ADDENDUM #1

Reference: Fire Alarm Upgrade – Ogden Second District Court
Administrative Office of the Courts – Ogden, Utah
DFCM Project No. 07123150

Subject: Revisions to Fire Alarm Drawings for Addendum 1

ALL SHEETS

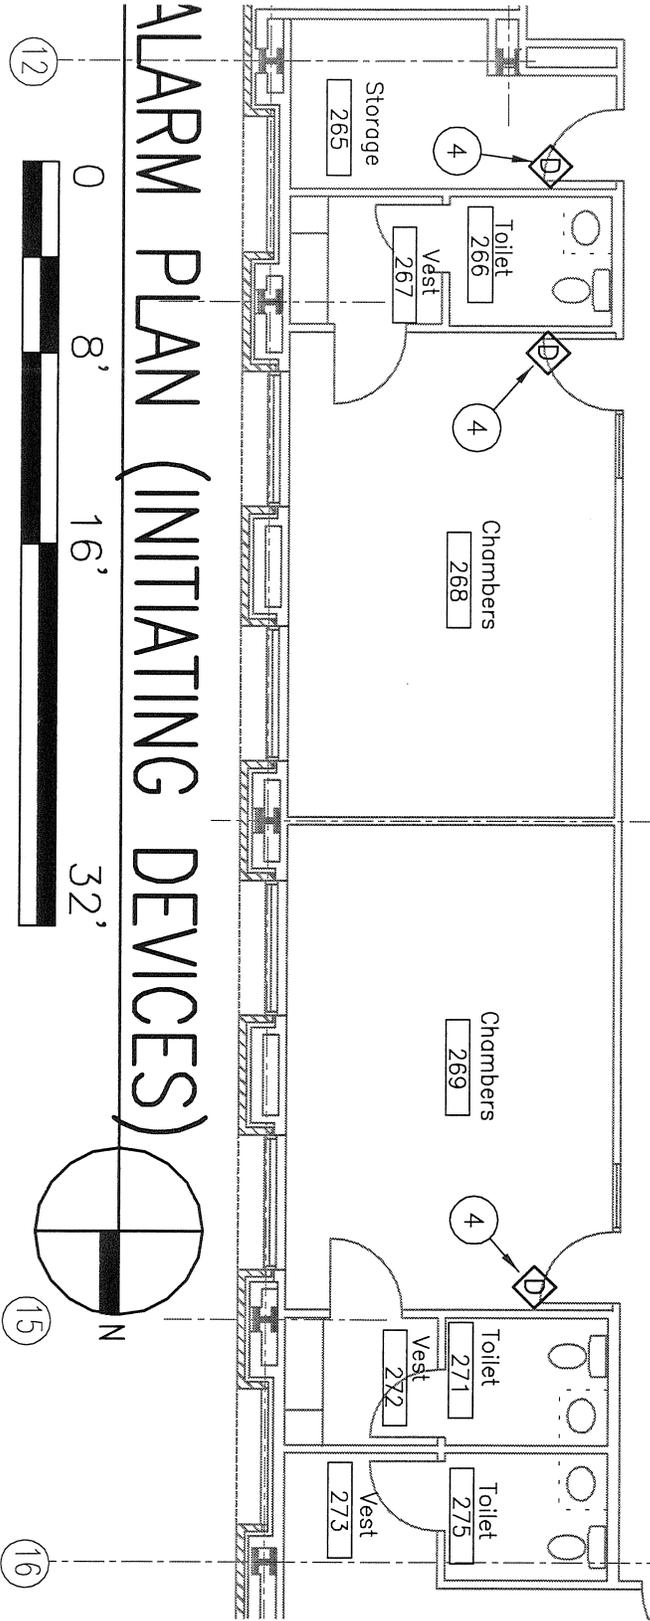
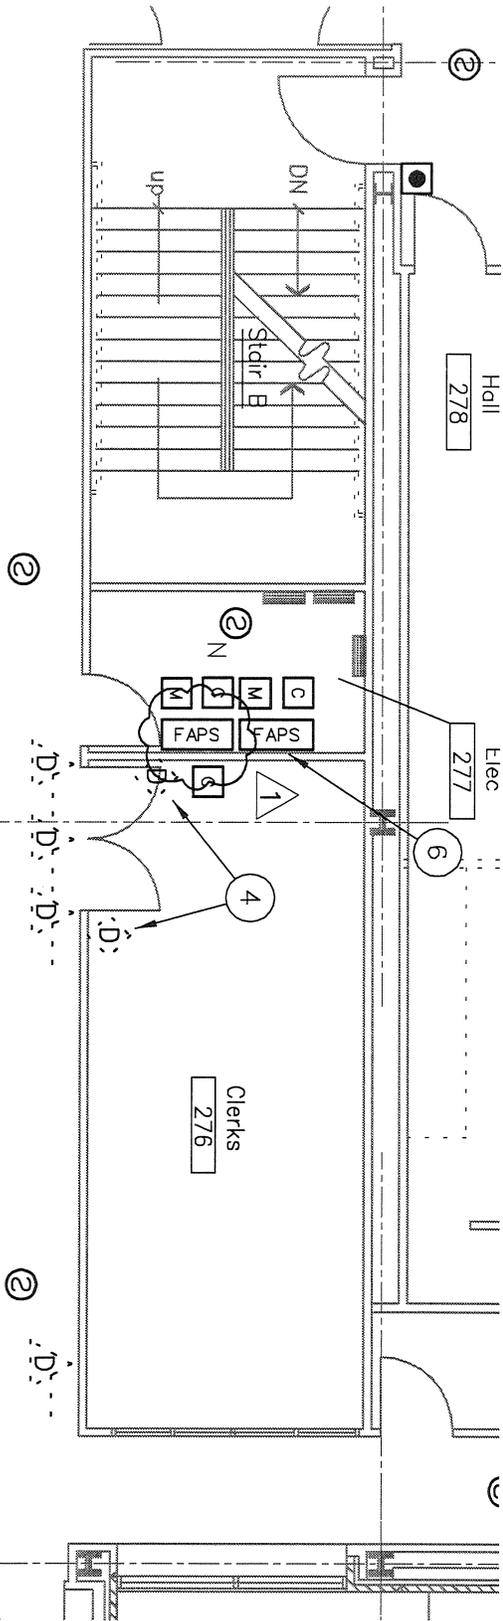
1. Edited key note 7 and key note 8 to indicate that owner (DFCM) will pay the cost of coordination with the elevator service contractor required to integrate the fire alarm system with the elevator systems.
2. Edited key note 8 to indicate that power shunt-trip breaker is existing for elevators 1, 2, 4 and 5. Only elevator 3 will require the installation of a new breaker capable of shunt-trip operation.
3. Edited information in Fire Alarm Equipment Legend for existing magnetic hold open devices to indicate that the existing devices must be replaced with new devices that will operate with a power supply of 24 VDC.

- ⑦ FURNISH AND INSTALL DETECTORS AT EACH ELEVATOR LOBBY, AT THE TOP OF EACH ELEVATOR SHAFT AND IN EACH ELEVATOR EQUIPMENT ROOM TO PROVIDE ELEVATOR RECALL FUNCTIONS IN ACCORDANCE WITH NFPA 72 AND ASME A11. PROVIDE ADDRESSABLE RELAYS TO INTERFACE WITH ELEVATOR CONTROLS AND PROGRAM RECALL FUNCTIONS AS FOLLOWS:

RECALL FOR EACH ELEVATOR SHALL BE INDEPENDENT OF OTHER ELEVATORS. OWNER TO PAY FOR SERVICE CALLS FROM ELEVATOR SERVICE CONTRACTOR REQUIRED FOR SYSTEM INTERFACE.

- ⑧ FURNISH AND INSTALL HEAT DETECTORS IN ELEVATOR SHAFTS AND MACHINE ROOMS. HEAT DETECTORS SHALL CONFORM TO NFPA 72 AND ASME A17.1. PROVIDE ADDRESSABLE RELAYS AND SHUNT TRIP BREAKERS (ELEV 3 ONLY. SHUNT TRIP EXISTING FOR ELEV 1, 2, 4 & 5) TO DISCONNECT POWER TO ELEVATOR EQUIPMENT UPON OPERATION OF EITHER HEAT DETECTOR. POWER SHUT DOWN FOR EACH ELEVATOR SHALL BE INDEPENDENT OF OTHER ELEVATORS. OWNER TO PAY FOR SERVICE CALLS FROM ELEVATOR SERVICE CONTRACTOR REQUIRED FOR SYSTEM INTERFACE.

SHEETS FA-2, FA-3, FA-4, FA-8

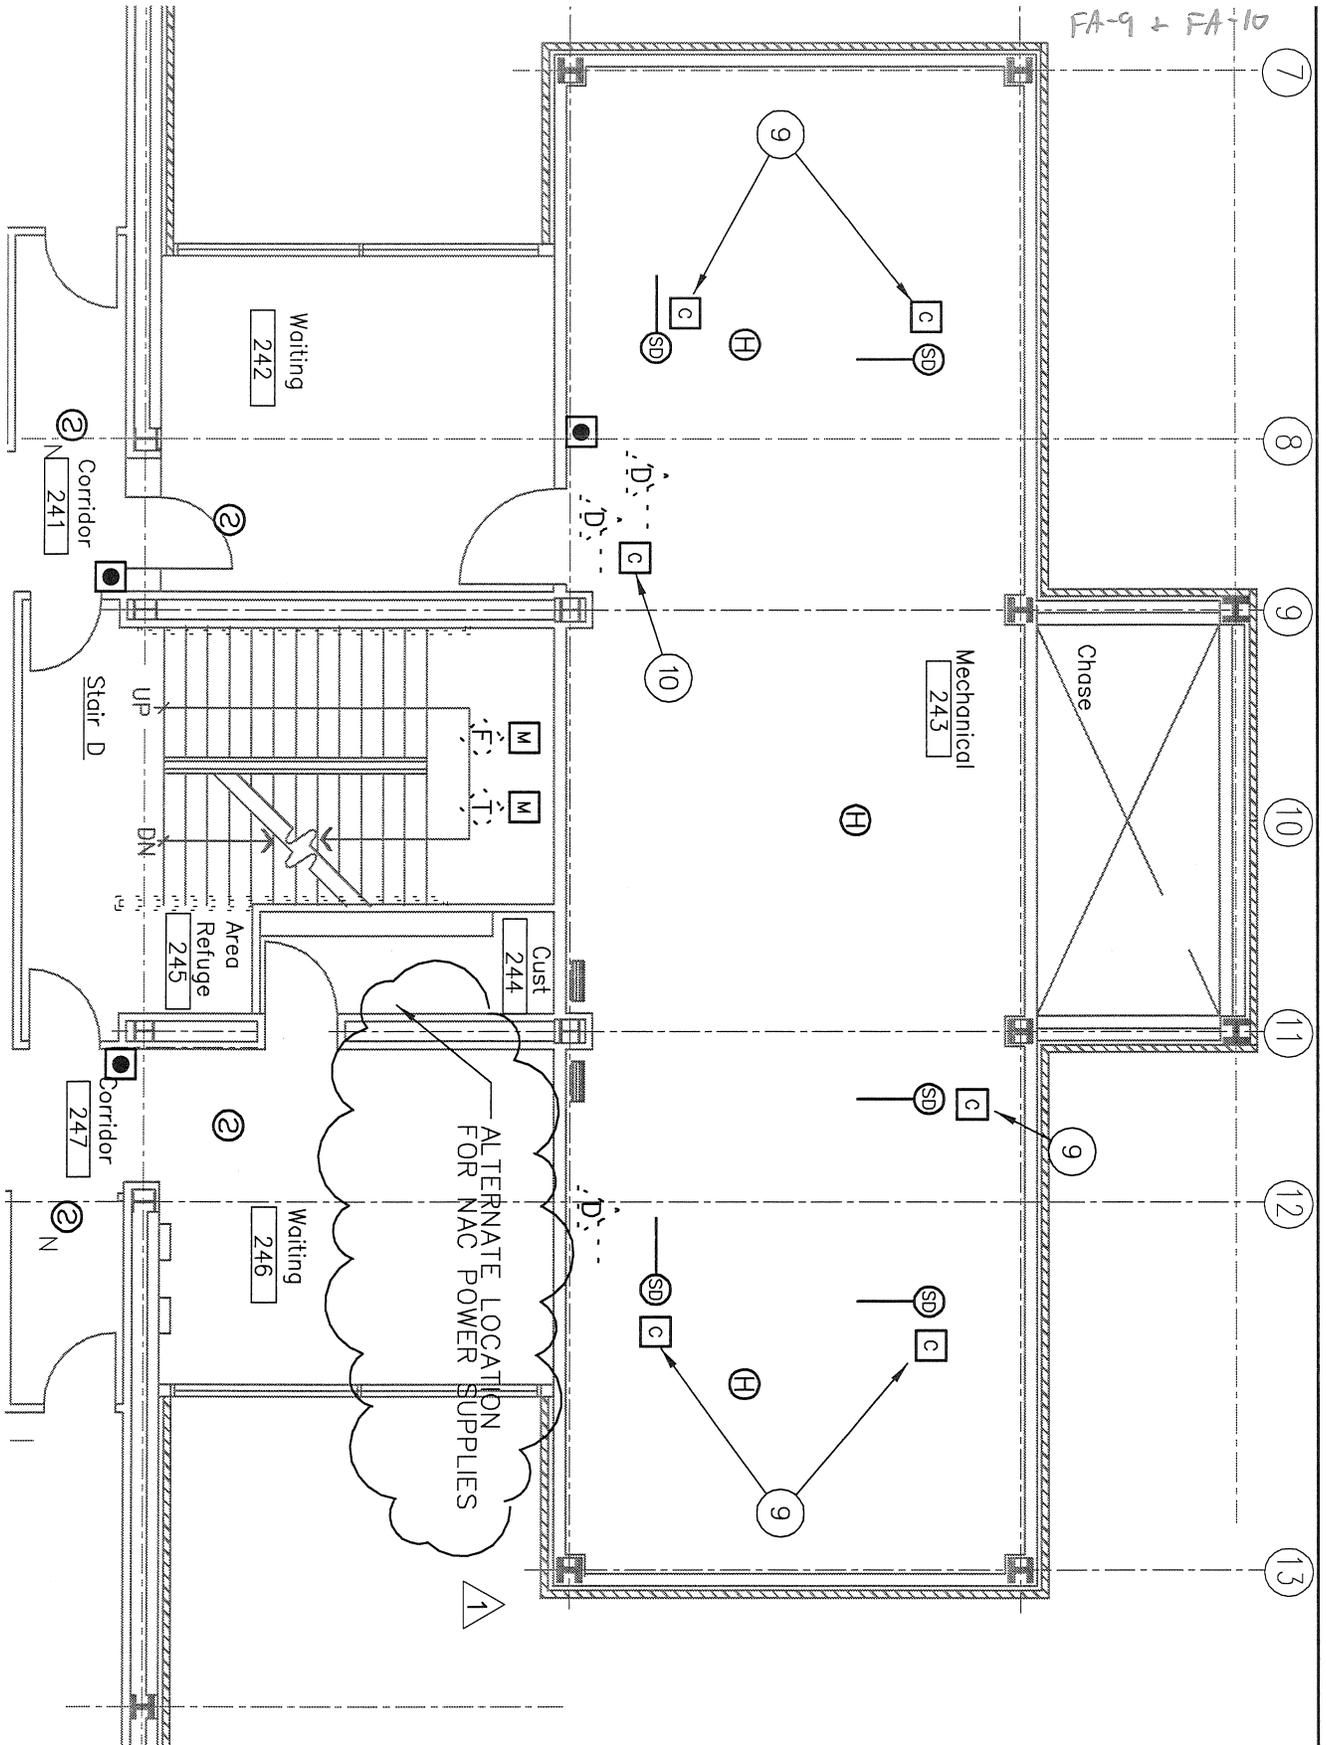
5. Added indication that Custodial Closet on west side of building is an acceptable alternate location for remote notification circuit power supplies.
